## INITIAL STUDY and CHECKLIST

**PROJECT:** Van Wycke Bicycle and Pedestrian Connectivity Project

**LEAD AGENCY:** City of Trinidad  
Planning Department  
409 Trinity Street, P.O. Box 390, Arcata, CA 95570  
(707) 677-0223, Fax: (707) 677-3759

**SHN Biological Report Figure 3**

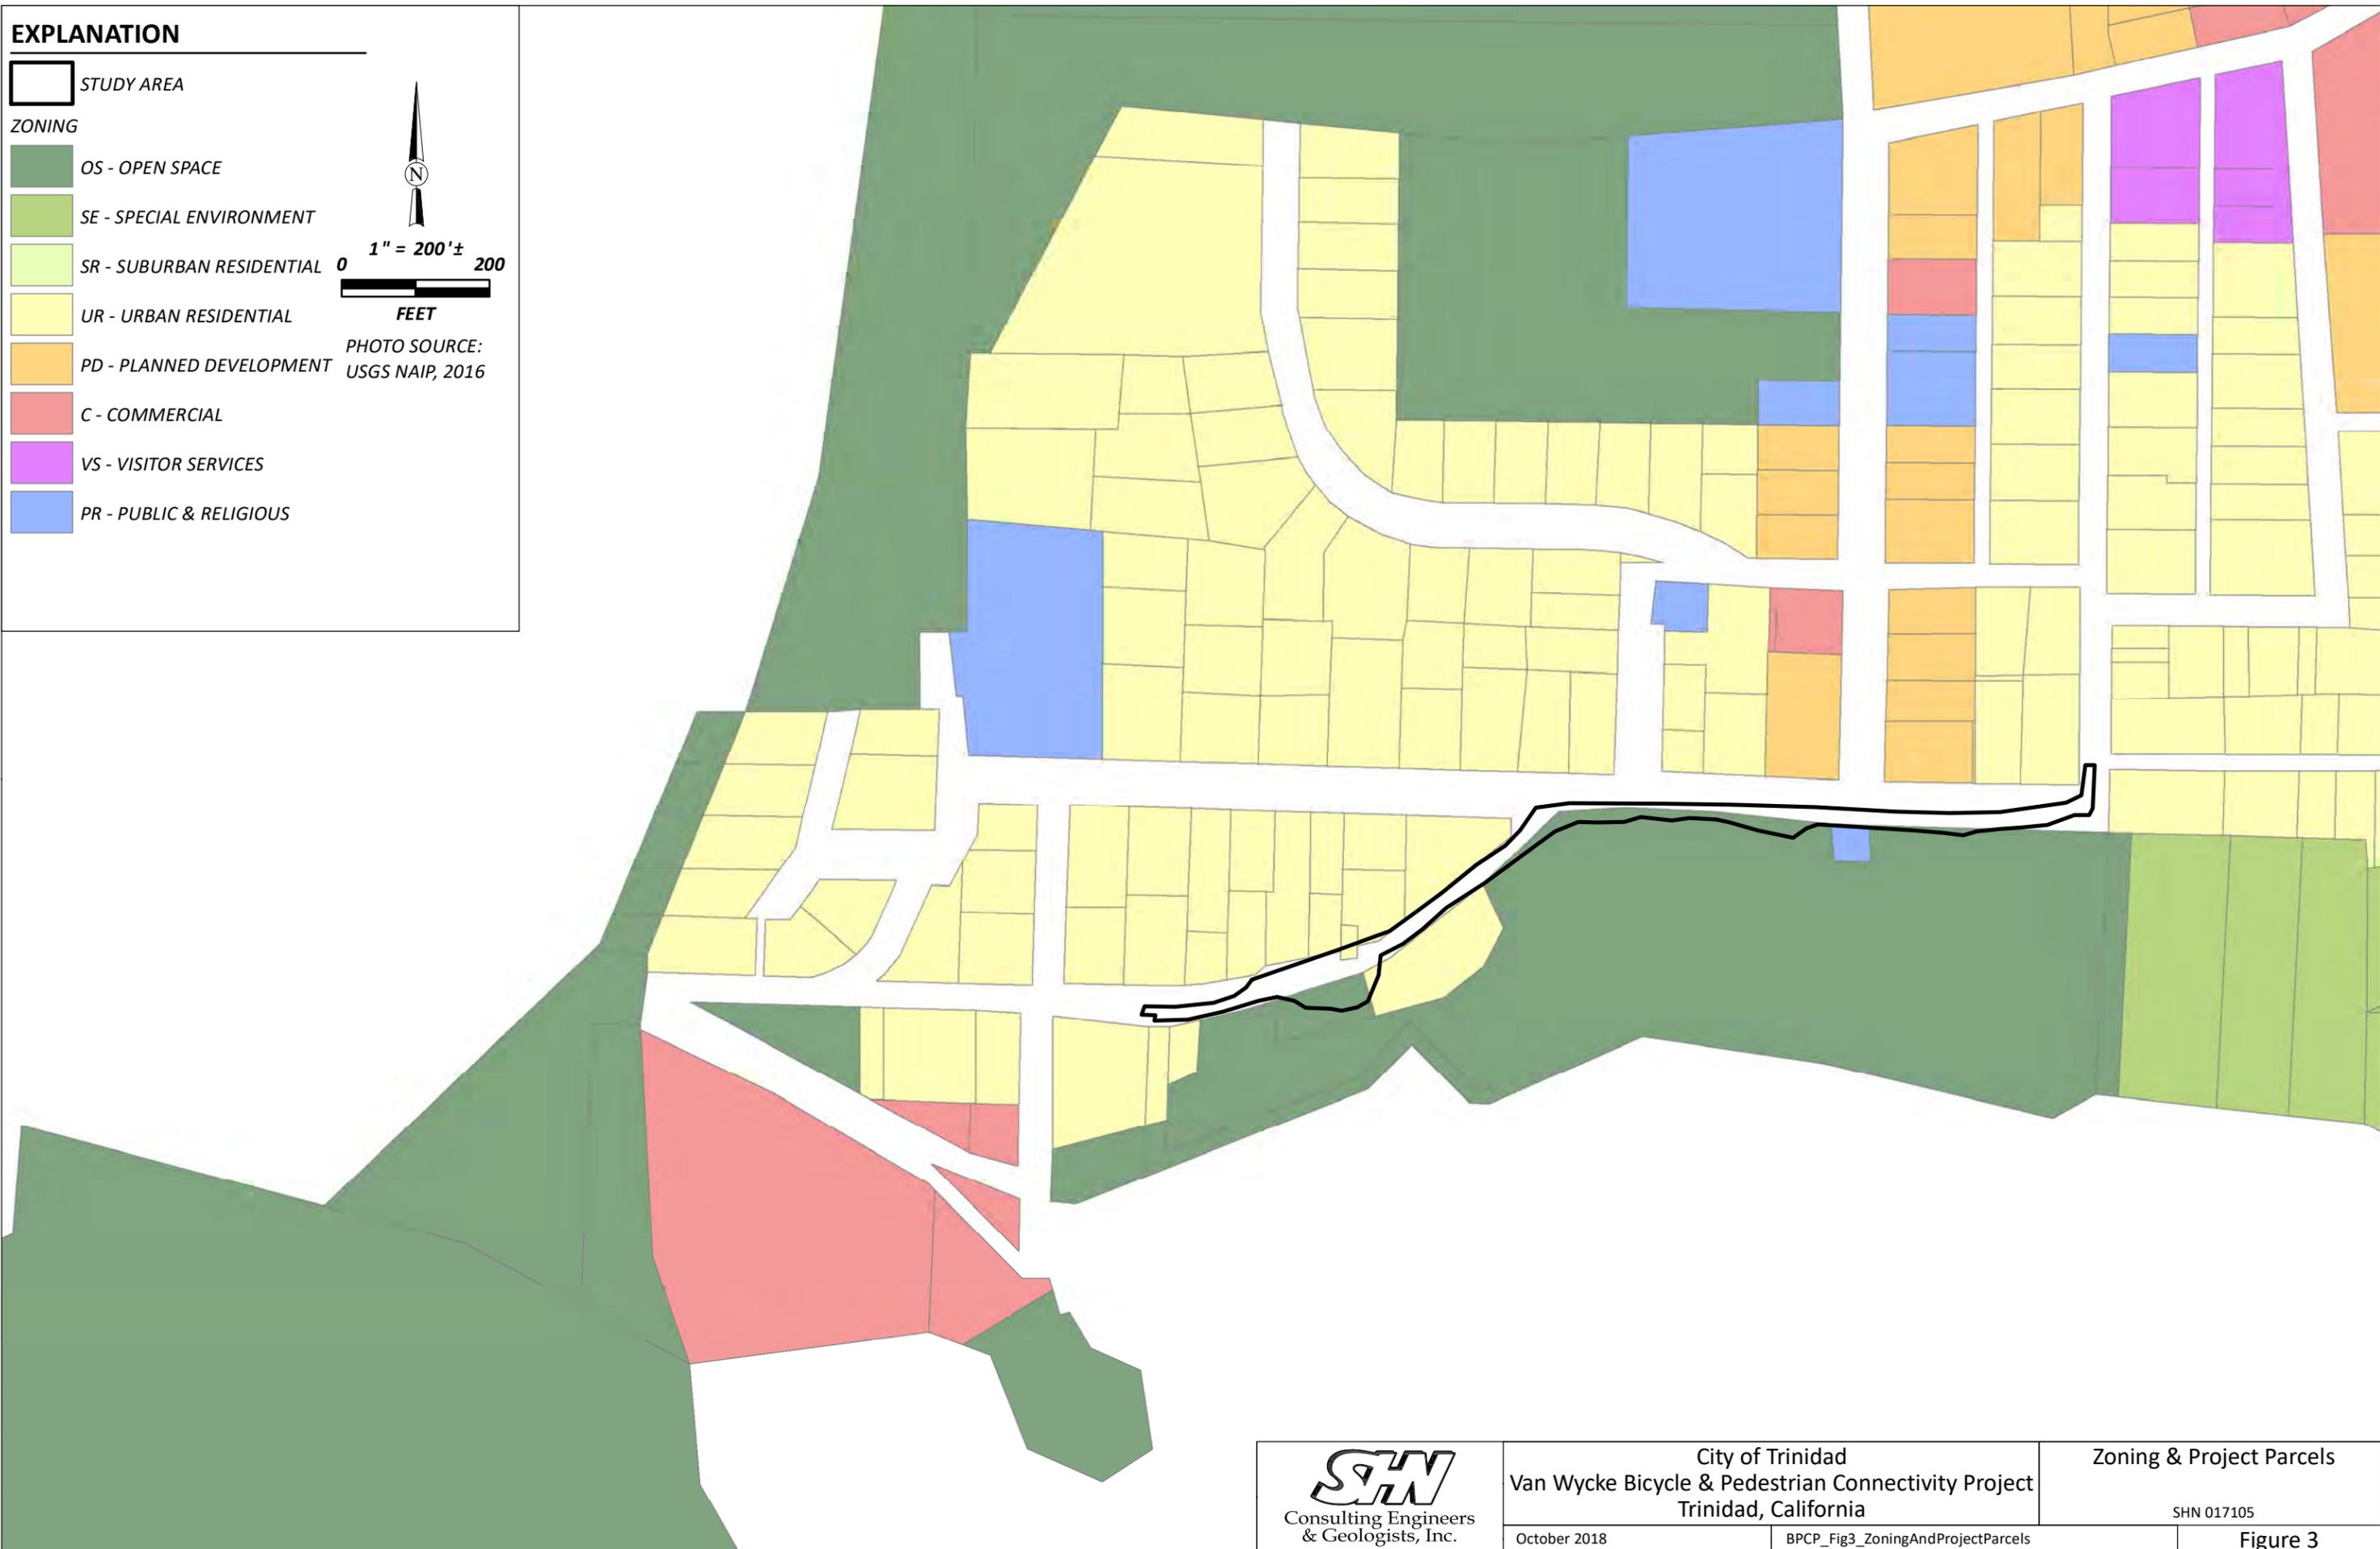
Comment D.1: Correct and clarify discrepancies in the scope of the project, including (a) the length of the retaining wall; (b) update Figure 2a; and (c) study area verses project area.

The IS/MND also indicates in part that "The project is located mostly within existing right-of-way<sup>3</sup>..." Figure 3 ("Zoning & Project Parcels") included with the Initial Study attachments depict the location of the "Study Area," but it is unclear from the exhibit whether development will occur within the full mapped extent of the Study Area. For the purposes of evaluating consistency of the project with the policies of the certified LCP, it will be important to accurately depict the full extent of all proposed developments as an overlay on the zoning map to establish whether proposed development would also occur within the adjacent Open Space and/or Urban Residential Districts.

Response D.1c: The study area shown in Attachment 5 (Figure 3 from the biological report) was used to determine the area that was covered by the biological survey. That study area exceeds the extent of the anticipated construction limits. It was also drawn based on the aerial photo in Attachment 2 and is only an approximate location when overlaid on the zoning map. As noted in the letter, this will be important for evaluating the final project design for consistency with the policies of the City's LCP. However, it does not alter the physical impacts of the project. No evidence was provided that the project will have significant impacts; no change to the CEQA document is needed.
